SUBJECT: CONSTRUCTION PHASE PROBLEM RESOLUTION REVISION NUMBERS 20,
22, 23, AND 24 FOR THE NATURITA DISPOSAL SITE

**UPPER BURBANK DISPOSAL SITE
CONSTRUCTION PHASE PROBLEM RESOLUTION FORM
RESOLUTION/REVISION No. 20**

NATURITA DISPOSAL SITE
CRR NUMBERS 20, 22, 23, & 24

UMTRA PROJECT - UPPER BURBANK DISPOSAL SITE
PROCEDURES
FOR SELECTION AND UTILIZATION OF SANDSTONE
FOR THE APRON TRENCH, EROSION BLANKET
AND SEDIMENT TRAP DAM

FIGURE 1 LOCATIONS OF DESIGN FEATURES

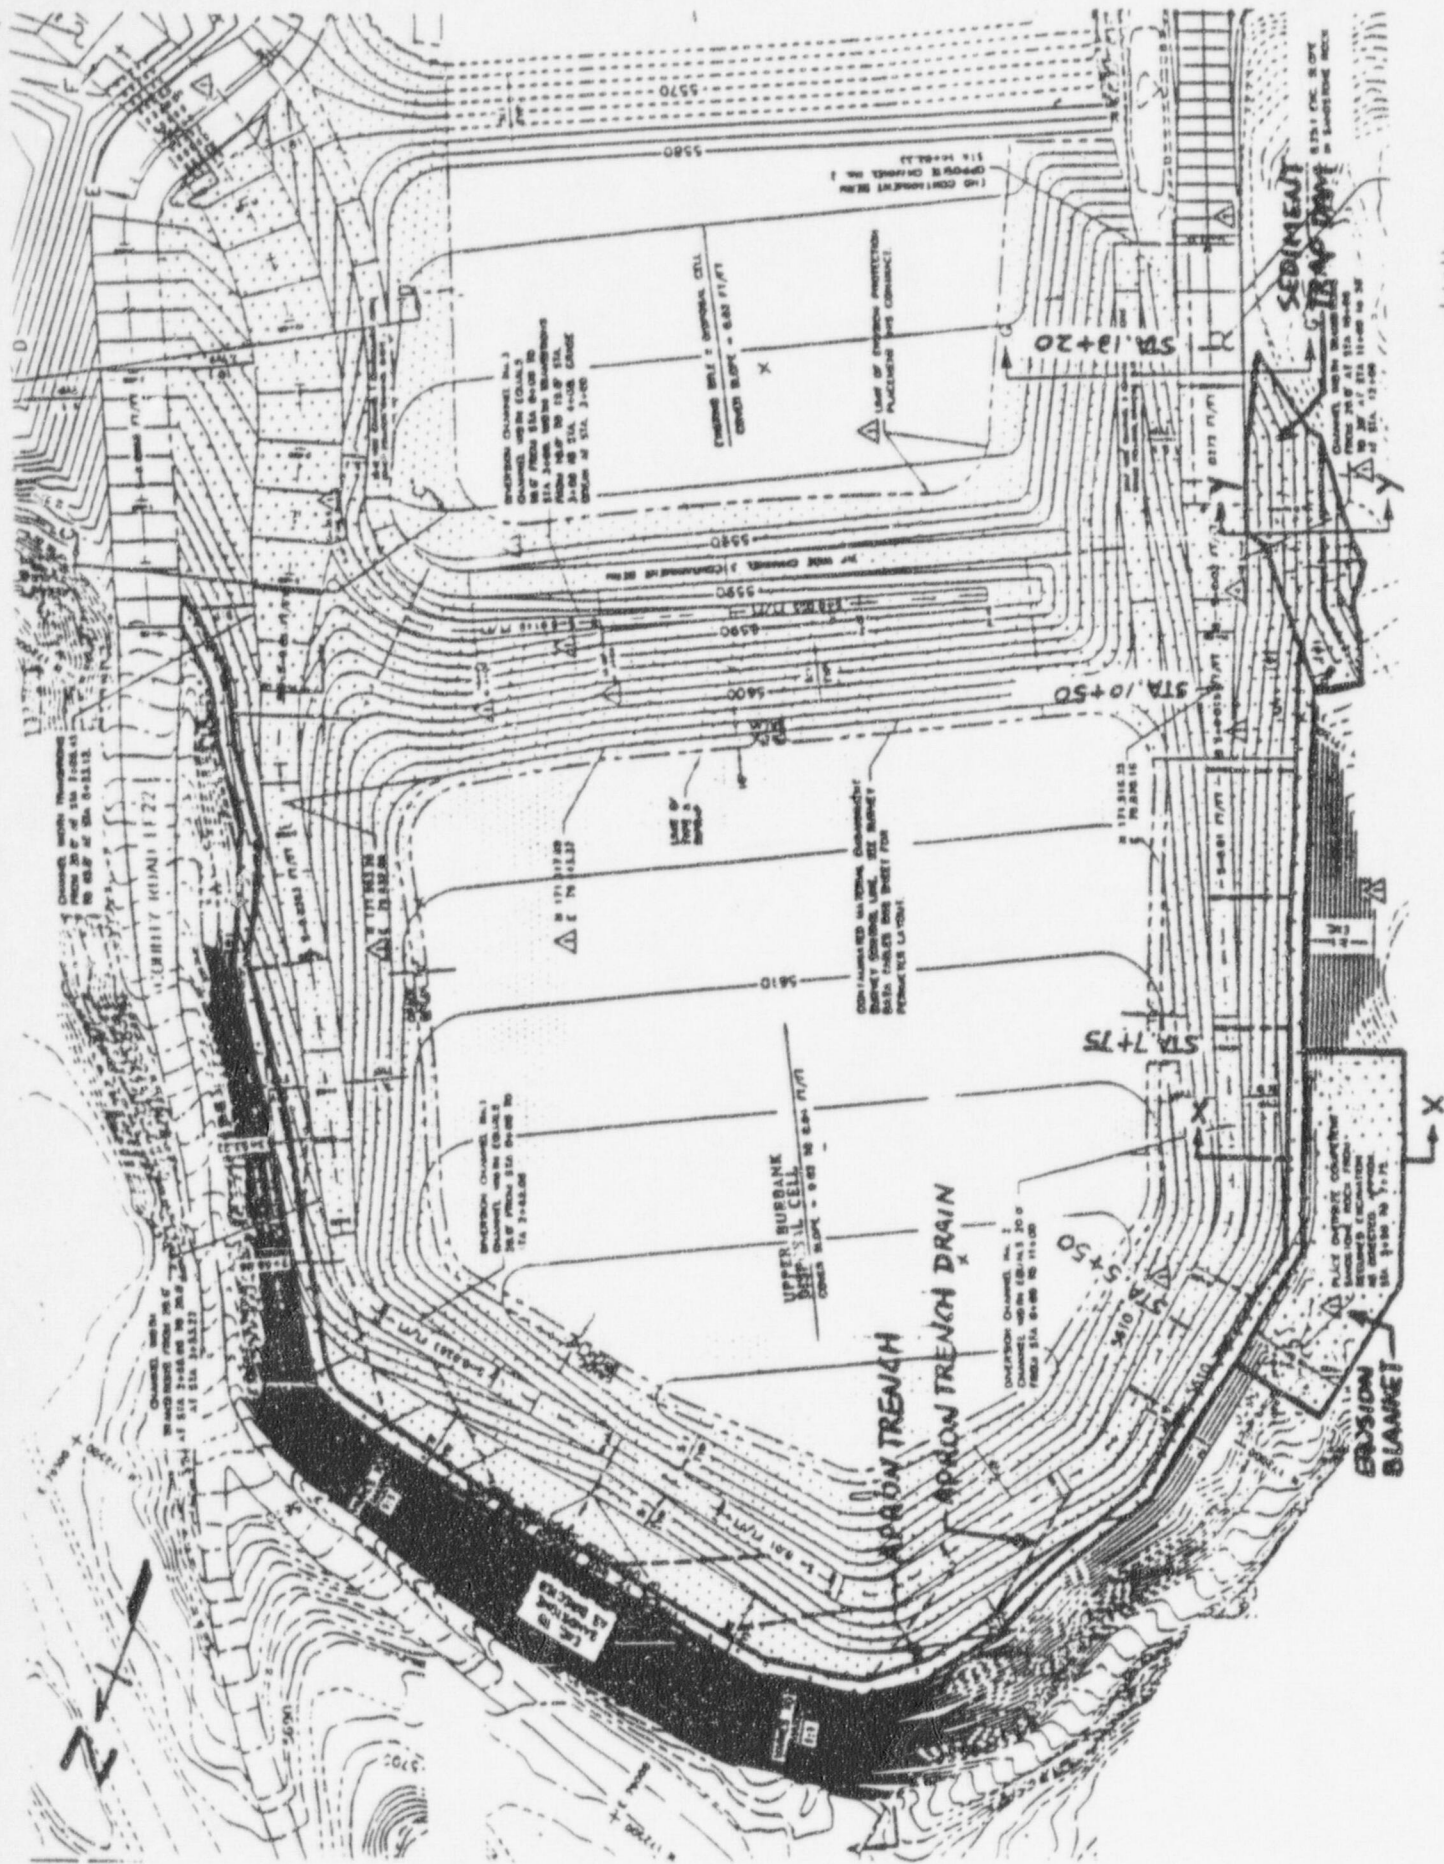
The current design for the Upper Burbank disposal site calls for placing sandstone riprap to establish the following three erosion control features: 1) an apron trench to regulate offsite runoff and serve as an energy dissipator; 2) an erosion blanket on the slope above the apron trench to protect the trench from potential gully flow; and 3) a sediment trap dam to control sediment originating from the upland areas. The apron trench, which is part of the diversion channel, is located along the north perimeter of the disposal cell. The erosion blanket and the sediment trap dam are located at Station 5+50 to 7+75 and at Station 10+50 to 13+20, respectively, of the diversion channel No.2. Figure 1^(pg 20) shows the location of these features, while Figure 2^(pg 21) depicts the corresponding cross sections and details.

FIGURE 3 - ROCK SCORE VS. SPECIFIC GRAVITY OF SANDSTONE

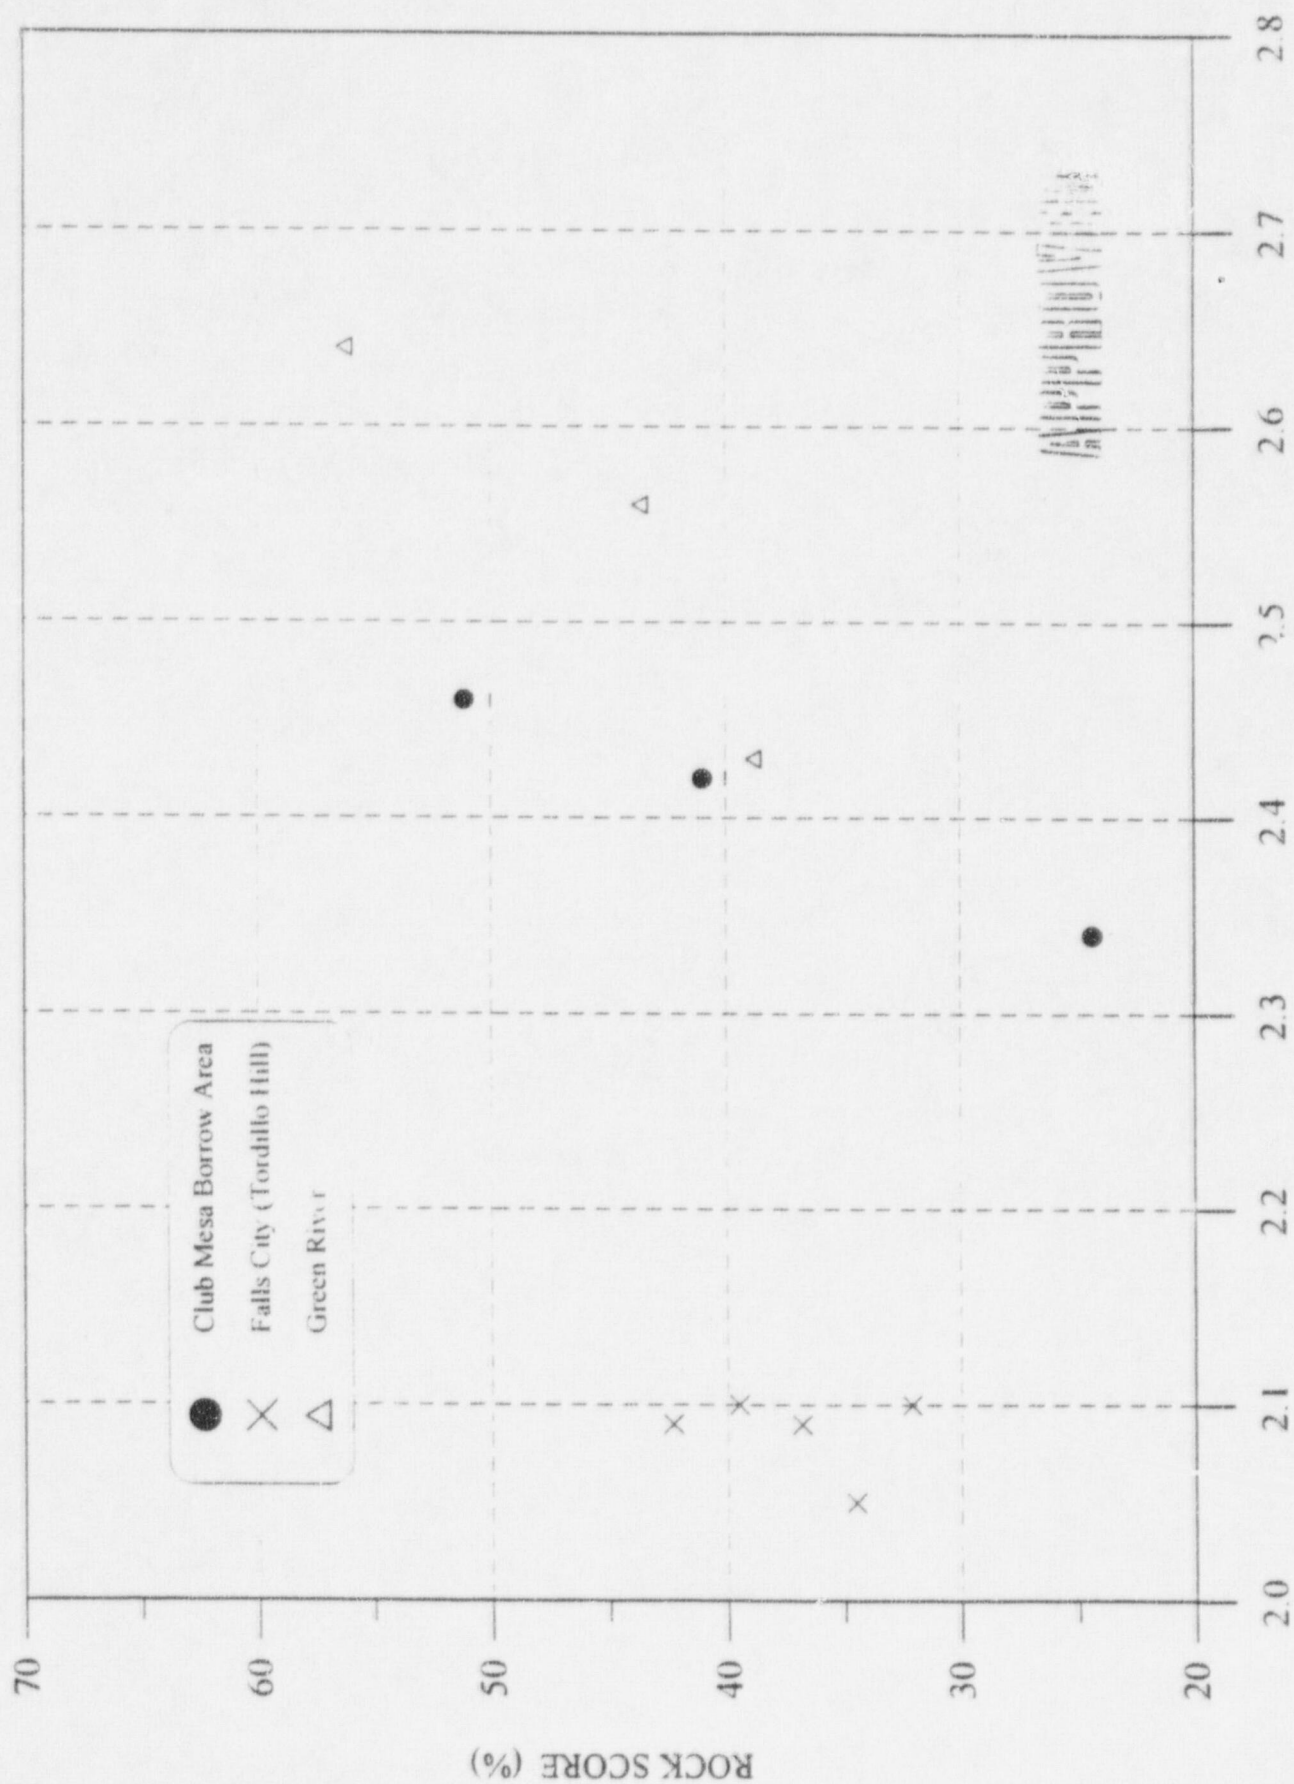
Compared to metamorphic and igneous rocks commonly used on the UMTRA Project for erosion protection, sandstone always has lower rock scores due to its relatively lower structural strength. Sandstone that scores greater than 50 is relatively rare, as can be seen from the limited test data available from the UMTRA Project shown on Figures 3 and 4. Reviewing data from the Club Mesa sandstones, a rock with a specific gravity of 2.54 would have to have an "R" value of about 57 to have a rock score of approximately 50. Field Schmidt Hammer "R" values for "satisfactory" rock were consistently between 40 and 45 with a few values up to 55 on high'y

FIGURE 4 - ROCK SCORE VS. SCHMIDT HAMMER REBOUND HARDNESS
OF SANDSTONE

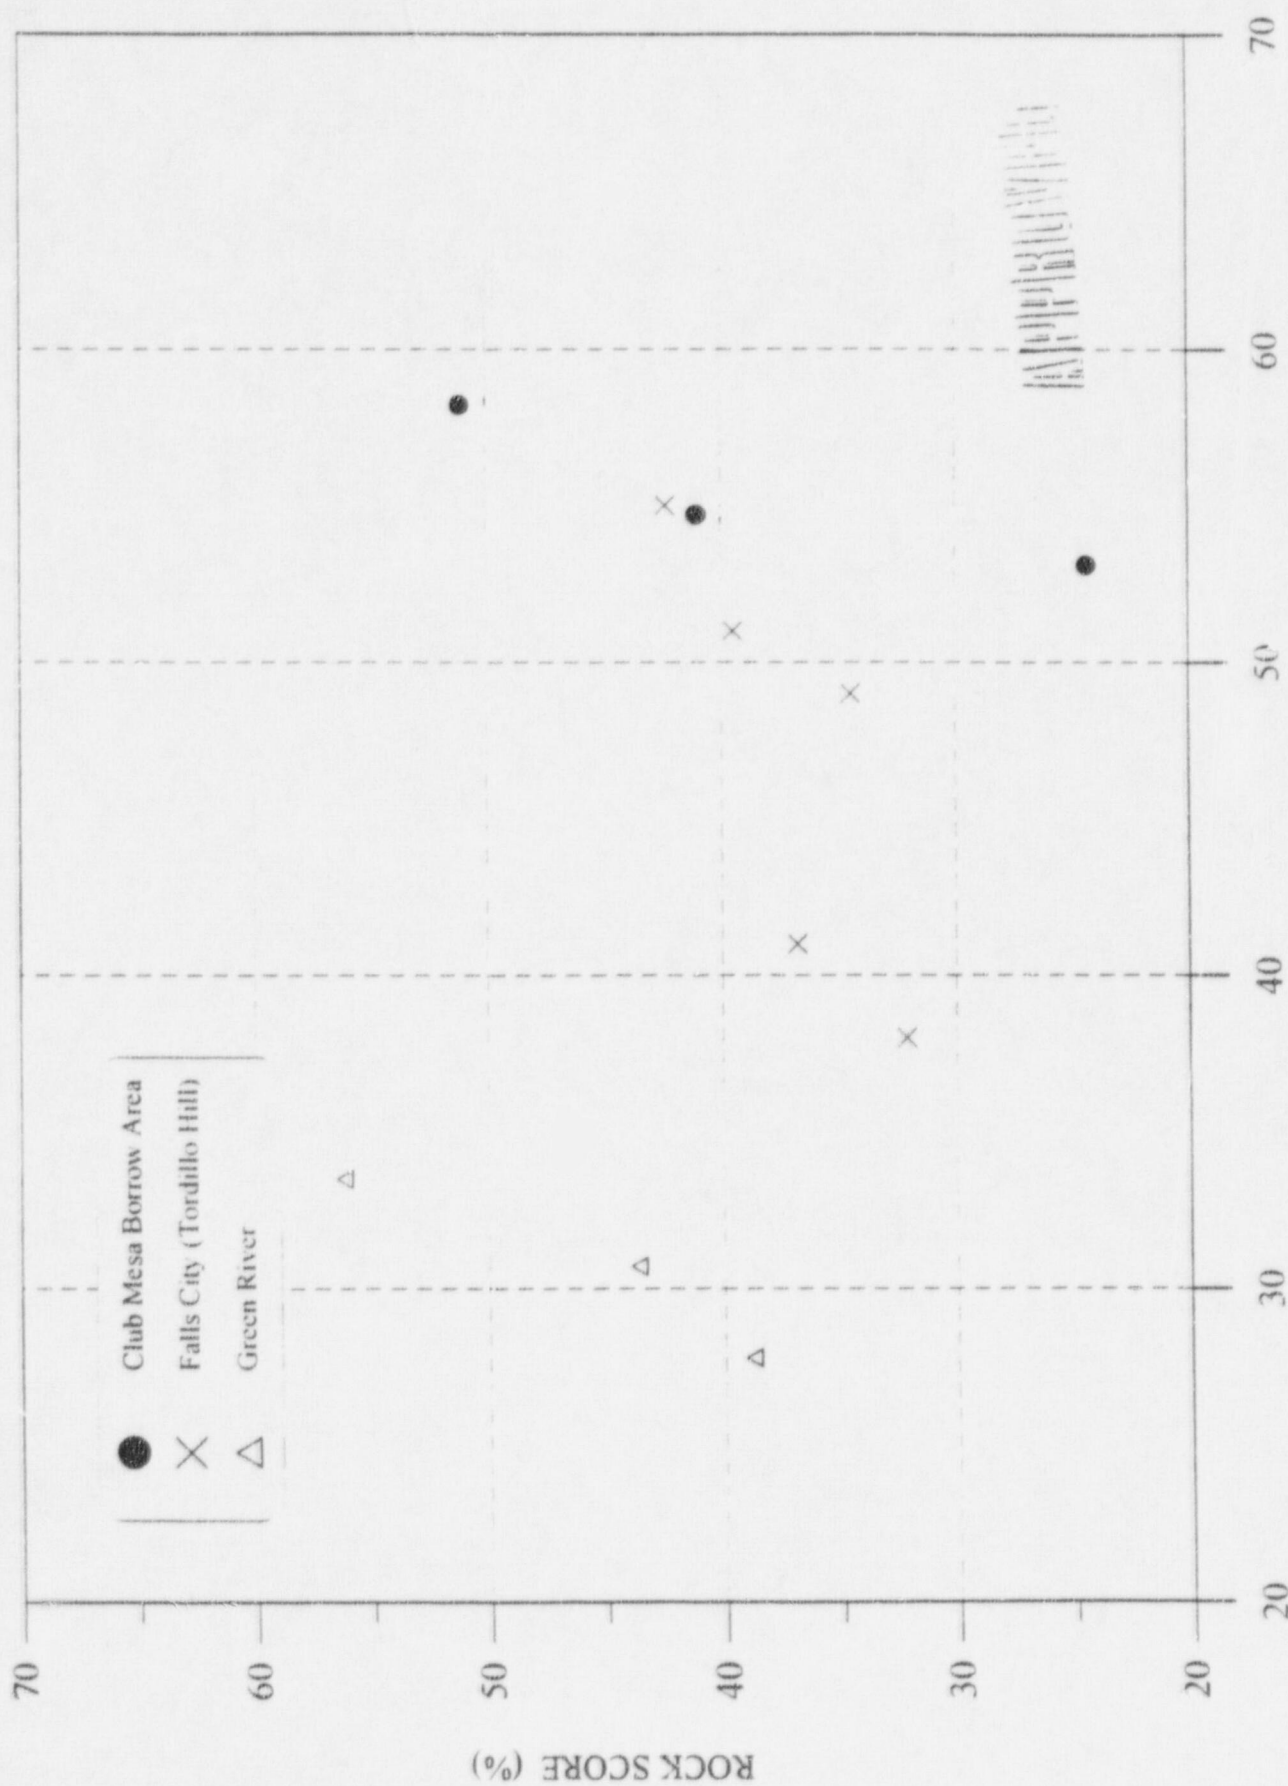
Rebound Hardness tests on sandstone boulders, Sample Nos. TAC-1 through TAC-14, with an AGRA Hammer were conducted by TAC on 22 April 1997. The same boulders were retested with a Type L Schmidt Hammer by MKES on 2 July 1997. The AGRA Hammer does not read "R" values directly, because it is not a "L-Type" Schmidt Hammer (used for rock), but rather the AGRA Hammer was designed for concrete testing. Using correlations to compressive strength,

the AGRA hammer test results were converted to equivalent "R" values. MKES also performed Schmidt Hammer tests on rock boulders which were retrieved earlier and stored at the laboratory (refer to Sample Nos. MKES #2 -#X). The test results are tabulated as follows:
